To: T10 Technical Committee
From: Bill Bissonette (Bill.Bissonette@intel.com)
Date: January 4, 2005
Subject: 05-009r1 SAS-1.1 OOB Amplitude Measurement Method

Figure 33 – Squelch detector

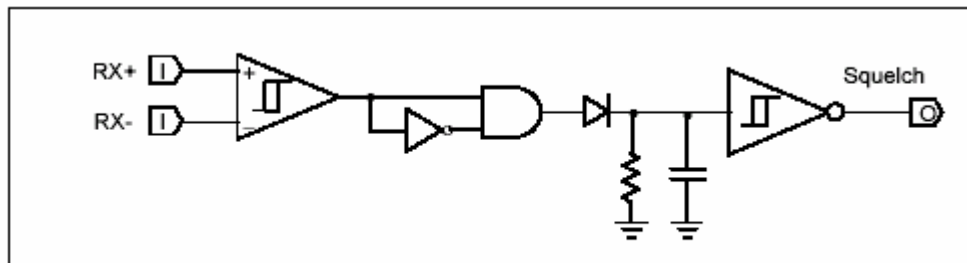
The following figure (from SATA1.0a) is an example OOB burst detector that infers the intended detection methodology. Each '0' to '1' (or idle to '1') transition to a differential amplitude that exceeds the receiver threshold causes a pulse (the length of which is the delay through the inverter) that charges the RC network which, in turn, holds the detection as valid to the next signal transition. The AND gate would be an XOR gate to detect transitions in either direction. Specifications for idle time between bursts allow for the 'slop' associated with the level detection hold-over time.
